**Re: Indian Point Unit No. 2  
Docket No. 50-247**

**Subject: NEI Pilot Program for Use of NUREG-1465**

**Responses to Requests for Additional Information  
Received from the Regulatory Staff**

**Responses to Requests for Additional Information**  
**Received from the Regulatory Staff**

Figure 1

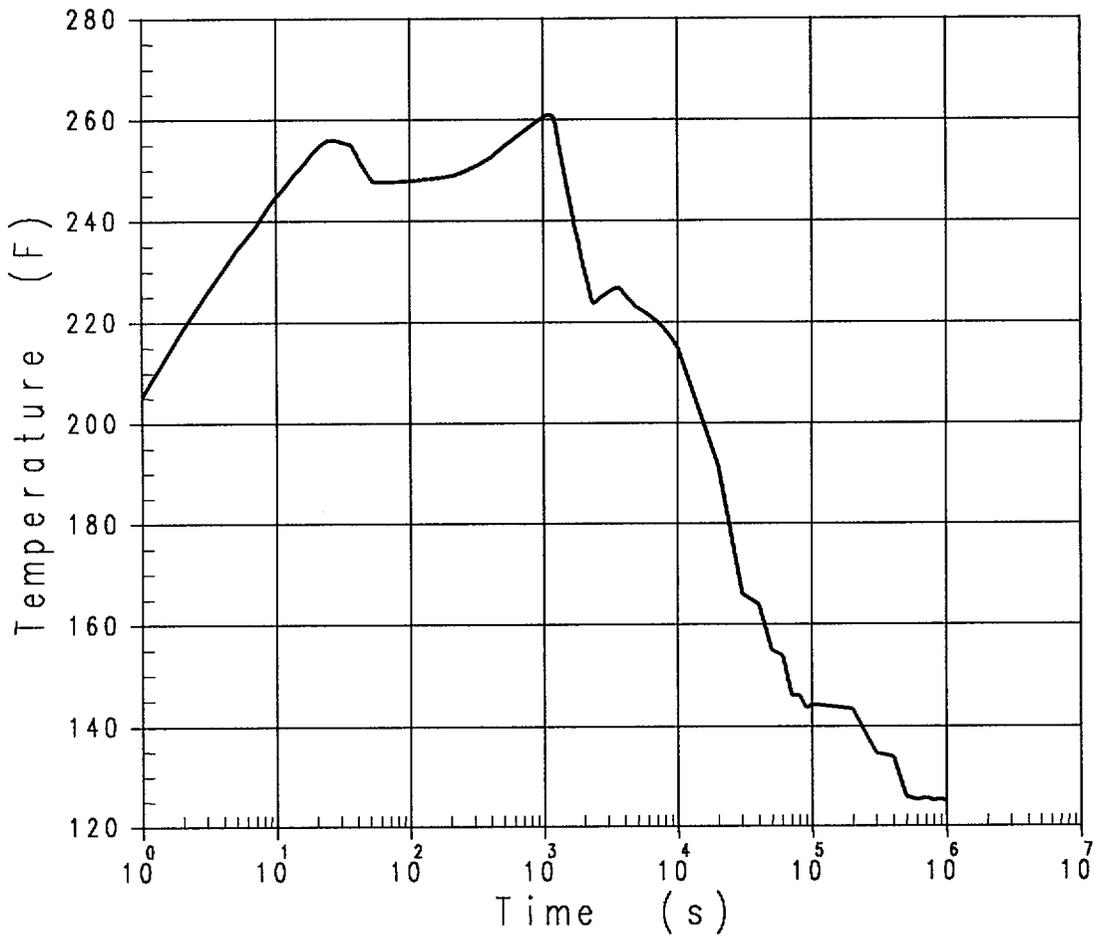
Provide an analysis of the control room and offsite radiological doses for the design basis loss of coolant accident which includes the contribution from potential external ECCS leakage post accident.

4. Containment sump water temperatures have been recalculated to more accurately define the conditions at extended periods post accident. These replace the values currently in the UFSAR. These temperatures are provided in Figure 1.
